September 27, 2004

#### MEMORANDUM FOR MILITARY/INDUSTRY DISTRIBUTION

SUBJECT: Recommended disposition of comments on MIL-DTL-83538/1B, /3B, /4B, /5B, /8B and /13. Connectors, Electrical, Circular, Umbilical, for MIL-STD-1760 Applications. Project numbers 5935-4644-001 through 5935-4644-006.

MIL-DTL-83538/1B, Store Receptacle

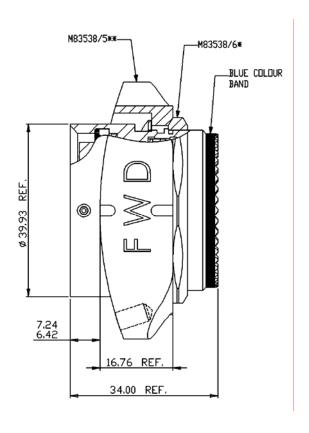
- a. Sheet 2 Ø2.34/2.24 dimension on the shell keys should be the diameter of the bayonets.
- b. 4.62 MAX dimension is incorrectly located. Dimension should be from face of the shell to the socket contact spring.

- a. Should to sheet 3, figure 2. Non-Accept. It is the diameter of the bayonet pins. Not clear what is intended here.
- b. Accept-Modify. See comment 3b.

# Comment # 3b

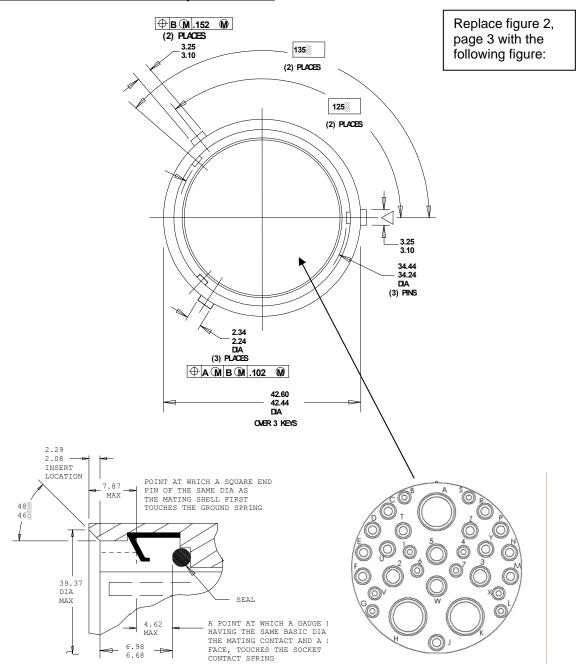
For the 7.87 dimension, rewrite the note as follows: POINT AT WHICH THE MATING SHELL FIRST TOUCHES THE GROUNDING SPRING.

Also, for the 4.62 dimension: It should be from the front of the shell, see MIL-DTL-83538/1A for reference. Also, the inside dimension line of the 4.62 dimension should be moved so that it does not coincide with the 7.87 dimension line.

RECOMMENDED DISPOSITION: Accept-Modify

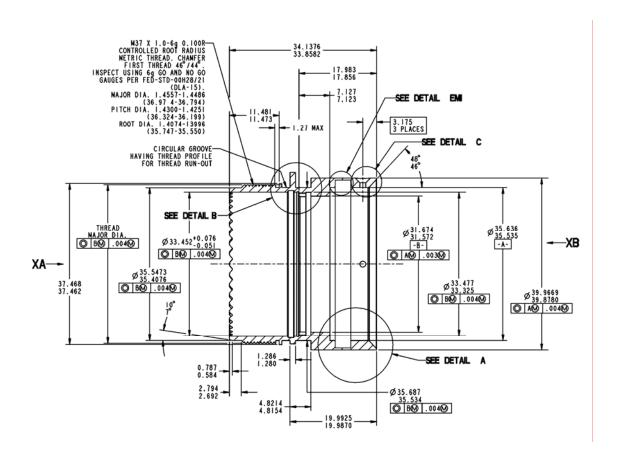
Resolution: Where is the wavy spring washer?

Also, the drawing on comment 3a is a little clearer, but there are slight differences in dimensions. Hold for discussion and input. This also applies to comments 4a, 4b, 4c and 4d.

RECOMMENDED DISPOSITION: Discuss

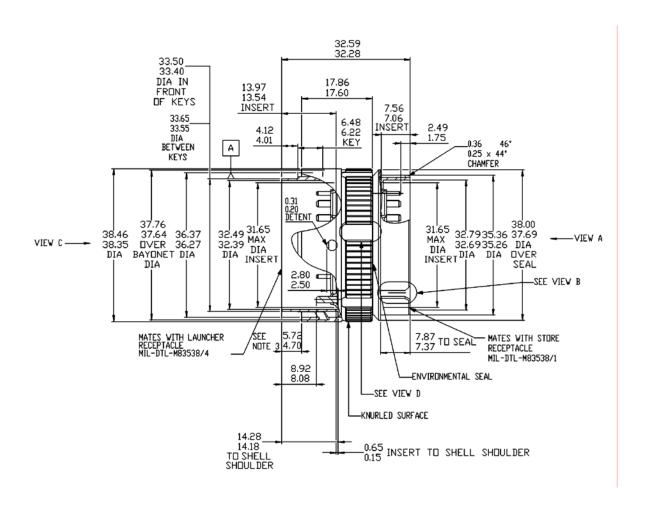
- 2) MIL-DTL-83538/3B, Buffer Plug
- a. Sheet 1 Location of interfacial seal on launcher receptacle side of the buffer plug is double dimensioned. One locating dimension of 13.97/13.54 is from the face of the shell to the interfacial seal. The other locating dimensions are 14.28/14.18 from the face of the shell to shoulder and then 0.65/0.15 from the shell shoulder to the interfacial seal.

- b. The 5.72/4.70 dimension from the face of the shell to the coupling nut applies when the coupling nut is pushed towards the rear (note 3). Does note 3 also apply to the 2.80/2.50 dimension from the shell shoulder to the 0.31/0.20 detent?

- c. Sheet 2 How deep are the six (6) 4.05/3.95 wide slots? The coupling nut already has a thin wall due to the specifications constraints and these slots would further weaken the coupling nut. In addition, it has already been proven that due to the confines of the launcher rail, the buffer can be installed using only finger and thumb operation. The forces required to couple the buffer plug to the launcher receptacle cannot be achieved using a finger and thumb. Therefore, are these slots necessary?

- See Mil-DTL-83538/3A. It is correct there, drafting lines have shifted.
    We will correct in the final draft. Also, see comment #6. Deutsch LTD is requested to send in a clearer drawing.

- b. Yes
  - b. See comment #6b, view d drawing. Still the depth of the slots on /3 coupling ring is missing. Manufacturers are requested to submit the missing data. Discussion item.

Replace figure 1, page 1 with the following figure:

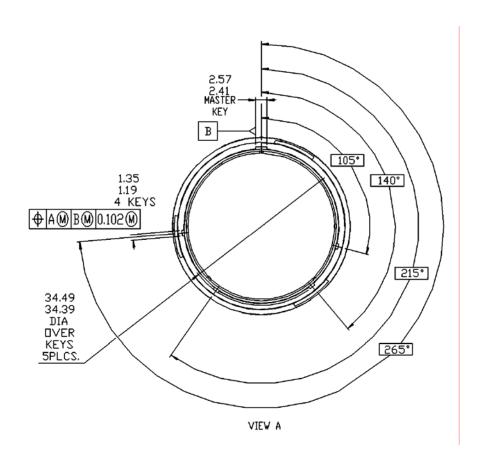
Although a more legible, clearer drawing would be appreciated, one that would fit nicely in a space of 6" X 9" on a page.

RECOMMENDED DISPOSITION: Accept

Replace figure 1, page 3 with the following figure:

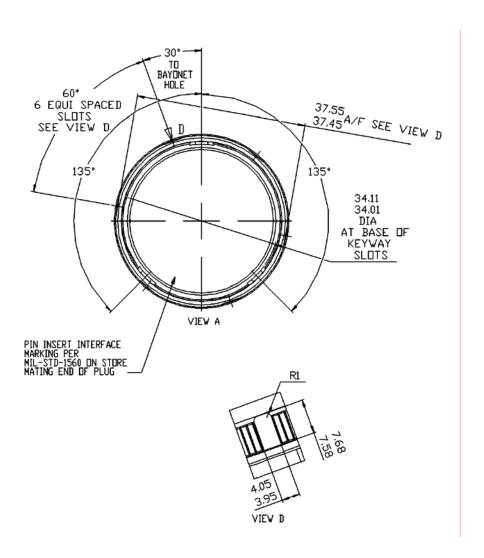
Mislabeled, shouldn't this be view C?

Discussion item.

RECOMMENDED DISPOSITION: Accept/Modify

4) MIL-DTL-83538/8B, Protective Cover

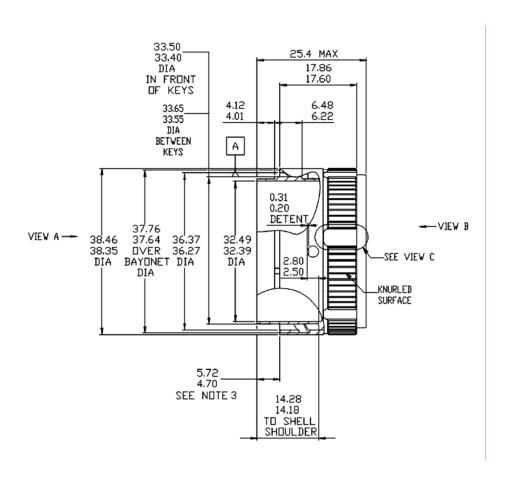
Sheet 1 - What component in the protective cover will insure that the coupling nut detents will apply a load on the launcher receptacle bayonets when the protective cover is fully mated to the launcher receptacle?

Resolution: This is a general concern question. Hopefully, the design of each individual manufacturer will assure that this cap will function properly, as intended.

Also, any further input that would help in alleviating this concern would be appreciated.
